Options for Revising Oconee Flood CAL Due Dates

Figure 1: Timelines

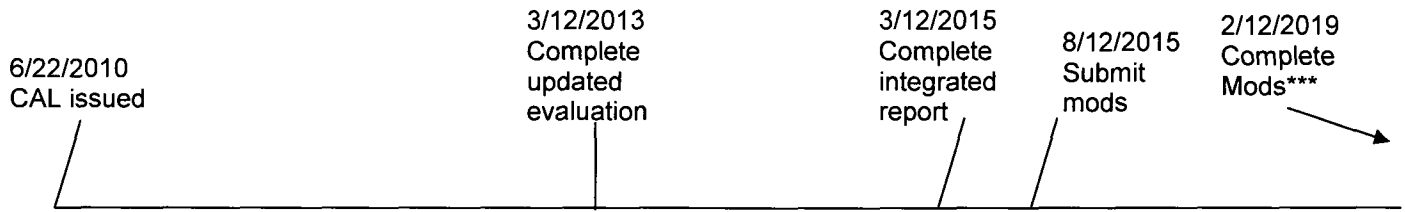
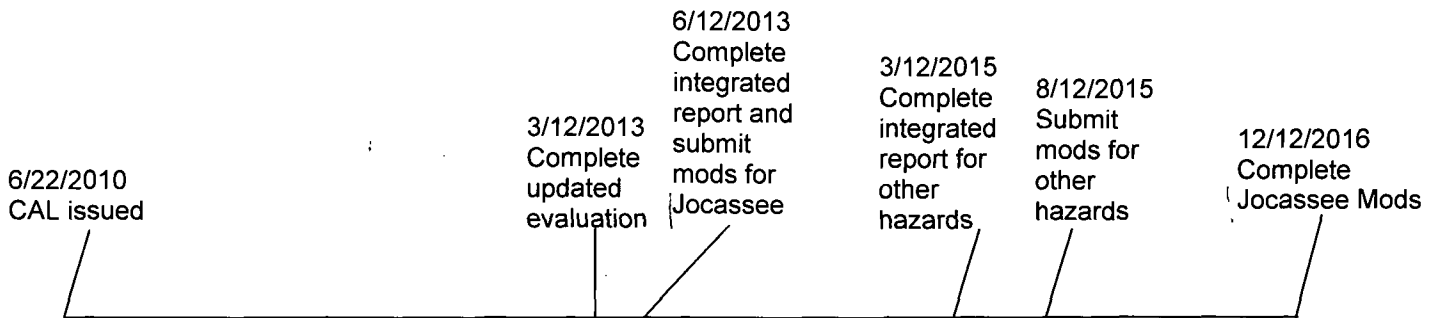
Figure 1 provides a graphical comparison of the current CAL, the licensee's proposed dates, and the staff's proposed dates.

Current CAL timeline would result in Jocassee flood modifications being complete around February 2016.

Oconee proposed changes would result in Jocassee flood modifications being complete around February 2019.

NRC proposed changes would result in Jocassee flood modifications being complete around December 2016.
